## **Strategic Roads Infrastructure Project (SRIP)**

## **PACKAGE SOEKARNO – HATTA ROAD SAFETY AUDIT REPORT Final Design and Construction Stages June 2010**

### **Present Condition of the Junction**

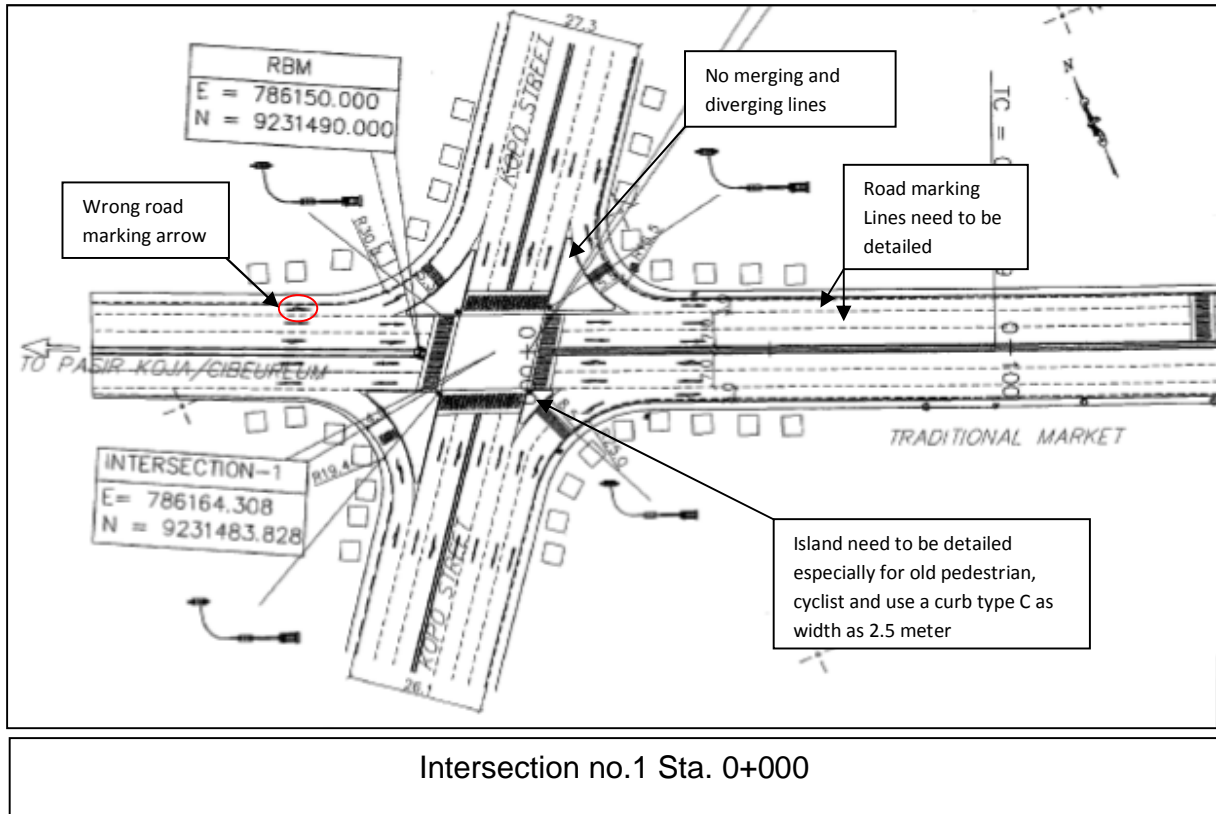
- Many of small bus or Heavy Bus are parked and stops near the Junction for rest or parking
- Bus were Pick up/down the passengers at main road

- There are old Traffic signal, It were properly located but many of traffic lights are not worked, remedial investigation and reinstatement work for those need to be carried out

- Re timing for green time is necessary needed. And additional traffic signals for pedestrian crossing should be proposed on technical justification
- Road Lightning at the junction are not worked (Installation problems or broken light are not investigate) need to be reinstatement or the head of traffic signal is not bright enough to notice the road users

- Intersection and Connection to local road are need to be light for comfortable the road users include the Pedestrian during night time
- No road marking lanes at the taper crossing to main road

- No signals light ahead to be posted in all approaches of the main roads
- No Rumble strips in all approaches the intersection and in both approaches of the minor roads.

- Most of the Islands or median are not for pedestrian service
- The Advertisement especially at Junction are brighter than Road Lightning and consequences make the road users are missing the sign.

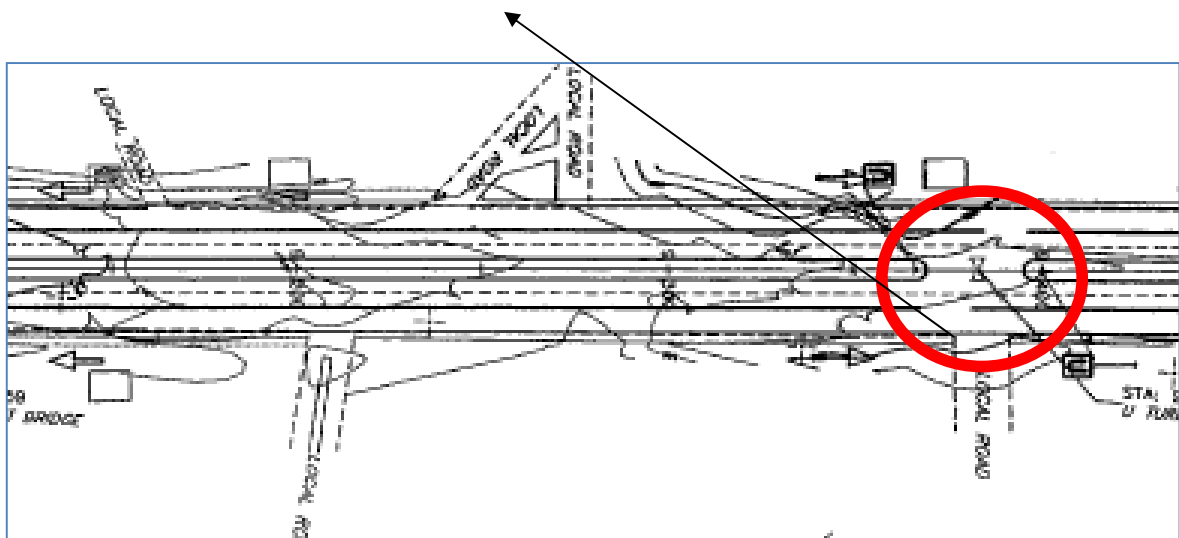
- No detailed design for Islands and most of island and median are not design for Old, Young, Cyclist and Children (Type C for curb are properly design)

- No Secondary Traffic Signals at the junction even though some intersection already have the secondary
- No Traffic Sign for Pedestrian movement (Pedestrian movement not arranged)

- Wrong detailed arrow symbol marking at taper lanes in each legs approaches the intersection.
- No detail drawing for road marking shows at Final drawing (type of lanes, merging and diverging lines, slow lane marking and etc)

- Bus stops/lay bays are not arranged near the junction
- No detailed drawing for Island, It is still use high curb (not purpose for the pedestrian crossing) the standard drawing for curb type c more appropriate for pedestrian

- No pedestrian bridge at approaching intersection for road which have more than dual carriageway (6 Lanes) are proposed

- No Rumble strips in all approaches the intersection and in both approaches of the minor roads.
- The curbs need to be paint at the Intersection

- No traffic calming and road lightning (Road Sign, Road Marking, rumble strips, etc) from local road proposed in final design

Blocked pedestrian crossing with signal light and crash protection poles

- Signal light ahead signs to be posted in both approaches of the main road about 50 meters before the intersection and in both approaches of the minor road about 30 meters before the intersection;

- Rumble strips to be installed in both approaches of the main road about 60 meters before the intersection and in both approaches of the minor road about 40 meters before the intersection;

- Signal lights should be provided in all approaches near the stop line and with secondary signs across the street facing the stopped vehicles;
- Pedestrian lanes should be provided with enough green times for crossing, refuge area in the medians, and free from trees, plants, electric and signal poles;

- Intersection approaches should not be positioned far from the centre making the crossing longer;
- Directional signs should be installed in both approaches one about 80 meters and another about 10 meters from the junction;

- Bus stops/lay bays should be provided in the technical justification and located about 70 meters after the intersection;

- Pedestrian Bridge should be provided in technical justification and located not less than 20m after and before intersection on the main road;
- Investigation for road lightning and Traffic signal condition are necessary, many of light was off during night time and most of traffic signal were not working well, the remedial/reinstatement work should be carried out and should be proposed on technical justification.

**W23 Sign**  
In common use in Indonesia to warn of need to take care, additional information need to be inform

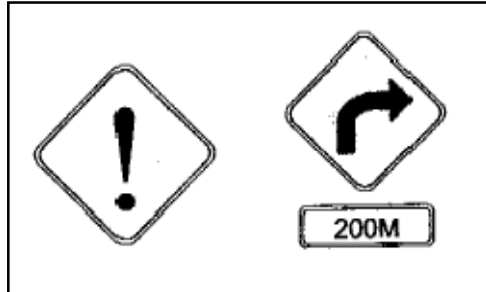
- W23 (warning sign) should be avoided and use the communicate sign is better

- An “Exclamation” sign does not provide sufficient information to road user for them to understand why they need to take care and probably slow down

Better to warn  
of bend ahead  
than just  
show  
exclamation

- Consider the use of yellow backing boards on important sign to help with speed reduction (speed limit)

Yellow backing boards  
& speed limit greatly  
increase effectiveness  
of any warning sign

Exhibit 9-92. Minimum Designs for U-turns

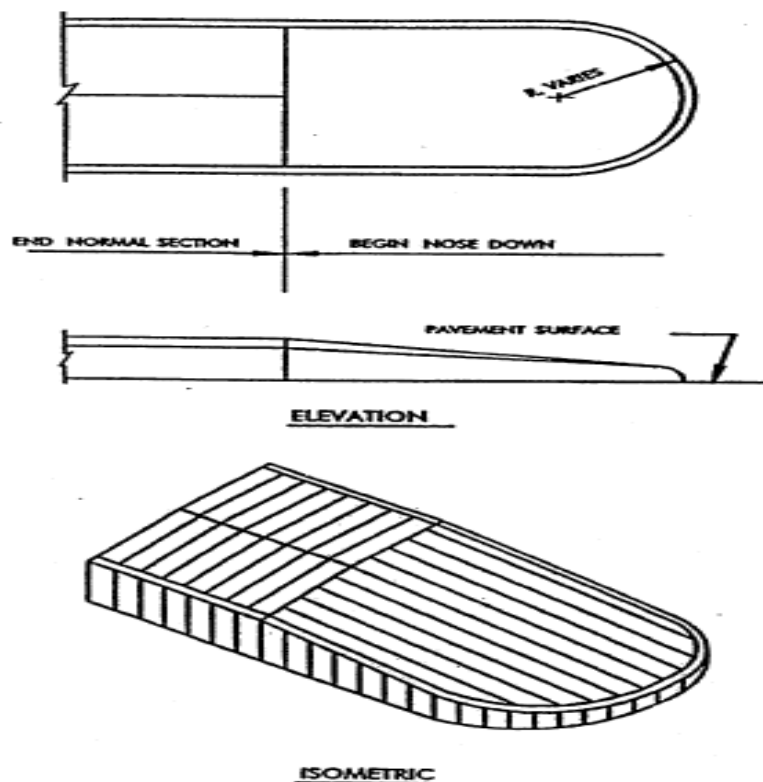
There are many gaps in median are likely to result in serious accident pattern, most of the U turns does not used Taper and most of them are narrow median. And all gaps in median will require highly visible advance warning signing and speed reduction measure.

Improving signing at wide U turns

- Prepared the standard drawing of gap in median including high visibility signing and traffic calming and used a taper for U turn design (The sample of standard U Turn and Narrow median are below)
- Continuous line marking, painting on the curb and symbol marking at U turn is necessary

- See requirement (Tata Cara Perencanaan Pemisah, Dirjen Bina Marga. No.014/BNKT/1990)

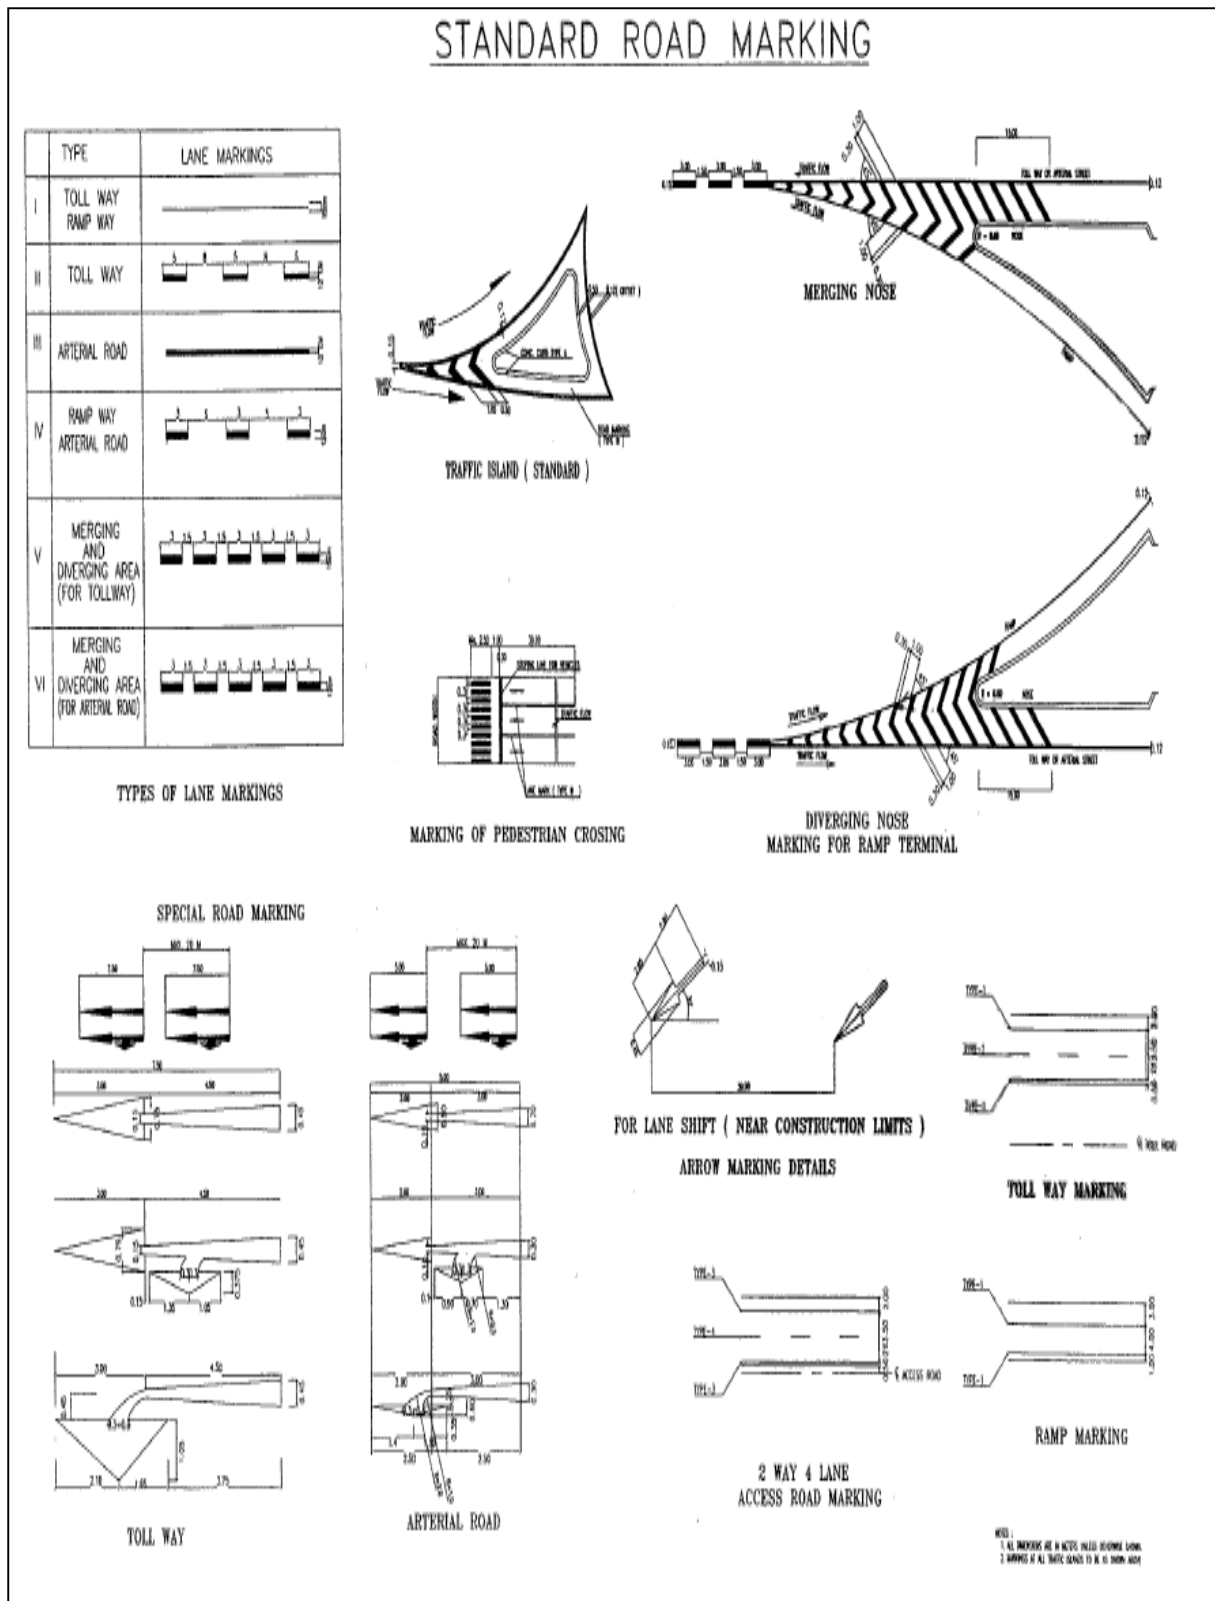
No detail drawing for road marking at Junction area plan, school zone and etc.

The detail drawing should consider as follows;

- Where longitudinal marking is formed by a solid line, it is designated as a ban for vehicle to pass that line. On a certain part of road segment for traffic safety reasons a double solid or broken line can be used. A single solid line can also be used to designate the edge of road lane.

- Used the Transverse marking is formed by a solid line to show where vehicles should stop at traffic signals or at a ban sign.
- Hatched markings that are edged by a broken line are used to inform drivers that they cannot enter the area unless it is safe to do so.

- Symbol markings are formed by arrows, triangles or word designations and can be used to supplement the traffic signs. Their purpose is to inform road users where they have not been fully informed by the traffic signs.

- Zebra crossings formed by solid marking lines traversing the traffic lanes and two solid lines crossing the traffic lane
- Road marking for School Zone and slow lane should be added

- Painting for curb and median is very necessary, the road users are limited visibility especially during night time, many of road lightning is off
- All road marking should be referred to "Tata Cara Pemasangan Rambu dan Marka Jalan Perkotaan" Bina Marga (no.01/P/BNKT/1991)

- The slow lane or motorcycle lane is needed considered, this road section are used by motorcycle (>70%), improving with provide the motorcycle lane or slow lane with road marking would be better solution

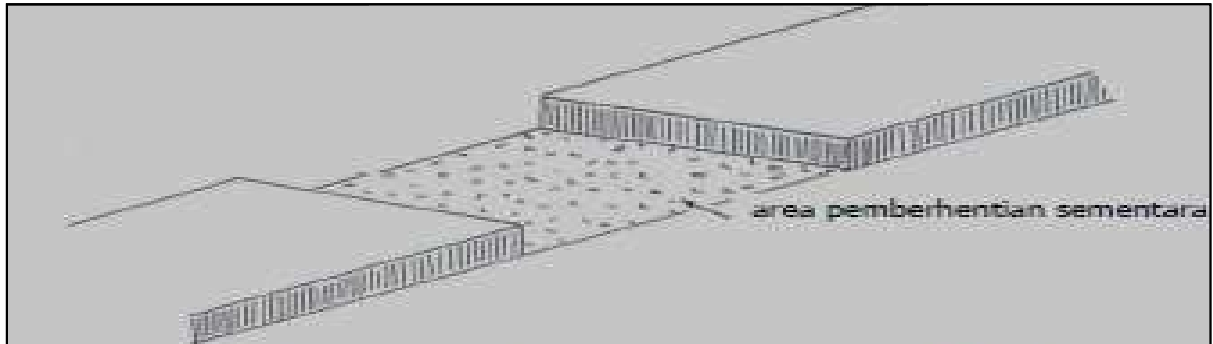
- None of pedestrian crossing is adequately detailed in the drawings.
- Trees will reduce safety (could hiding the pedestrian at pedestrian crossing area)
- Stopping Bus/Parking Car near the pedestrian crossing should not be allowed.

- If the road is more than dual carriageway, designing with the pedestrian bridge is better for safety pedestrian crossing especially at public facility if the road is more than dual carriageway

- High visibility area for pedestrian crossing, Traffic calming or speed limit, flasher may be needed or pedestrian signal with push button should be installed,

- Rumble strips should be planting to reduce the vehicles speed
- Island and median at the pedestrian crossing should be passing through without obstacle (height of the curb at Island and median should be lower down) All the pedestrian crossing should have protection at the middle of road (median)

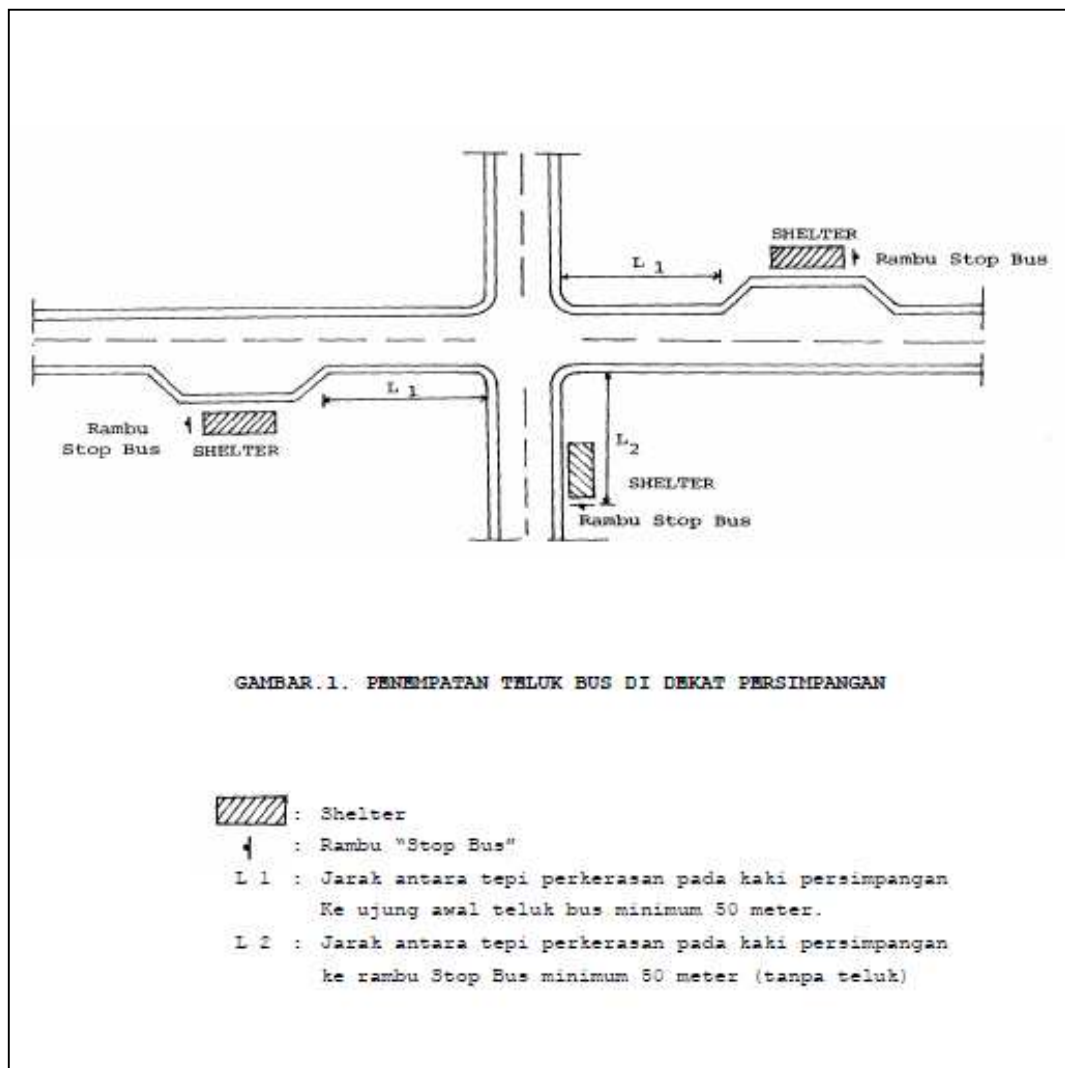
Bus stop/lay was not design in the final drawing, most of the bus always park on the main road approaching the junction

No Bus stop and area parking are design on Soekarno - Hatta road especially at market, public area and school zones. Even though there are much Heavy vehicle (Truck, buses etc)

Obtain details of existing and proposed road accesses in the vicinity of the potential crossing point (within 100 metres), existing and future kerbside parking and loading areas, and informal kerbside activities, all of which may affect sightlines and safety.

- To reduce the risk of parked vehicles contributing to an accident it is important that designs should minimize parking in main traffic lanes.

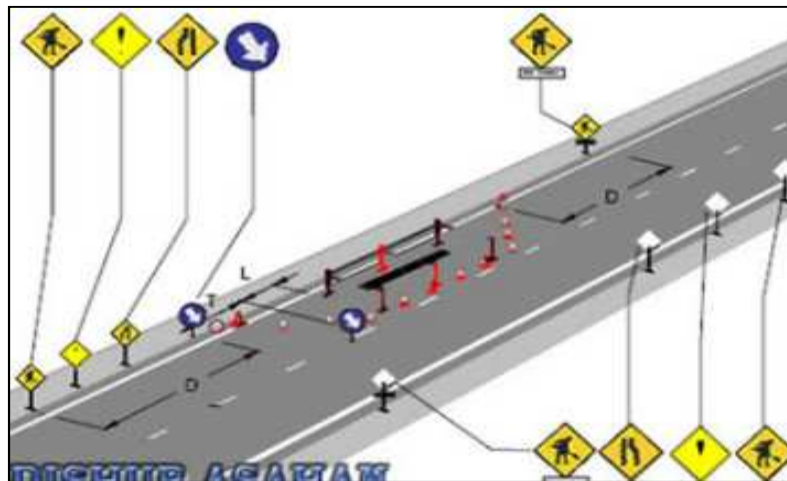
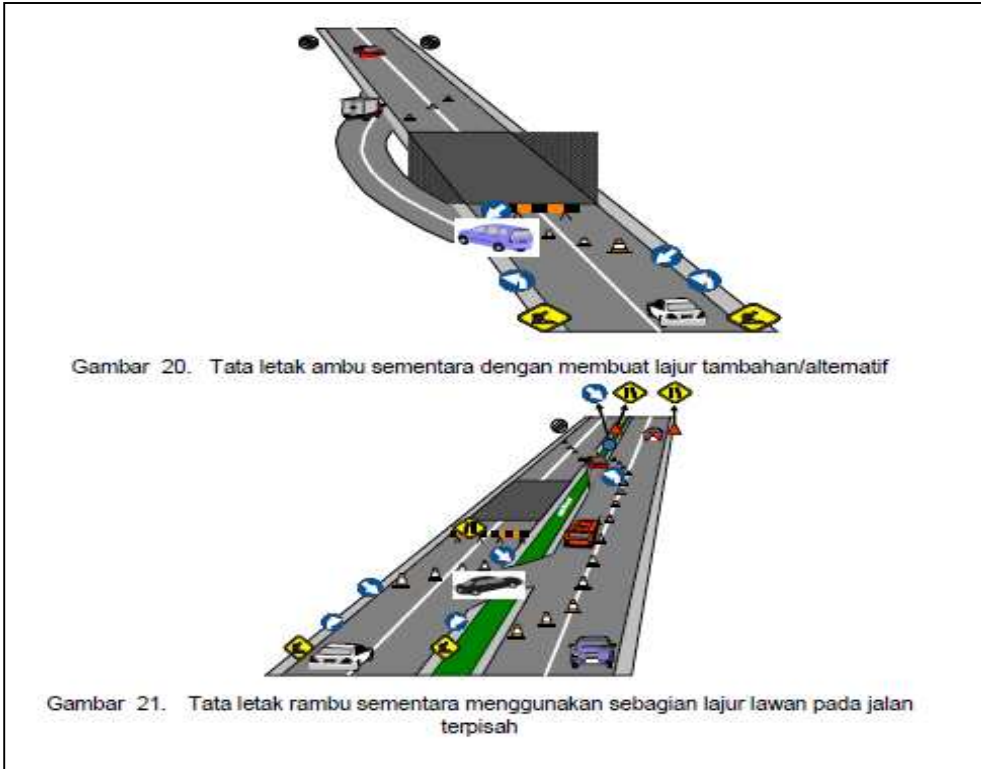
Many advance sign was lost, only cones and warning boards

Better Uniform, All Workers already have Reflector Jacket

- Advance temporary warning should be installed
- All the Workers should use a reflector Jacket during on work
- Additional cable/rope reflector lines would be better installed between cones
- Potholes and road deterioration should be marked with cones or paint.

- The Traffic flows should be maintenance.
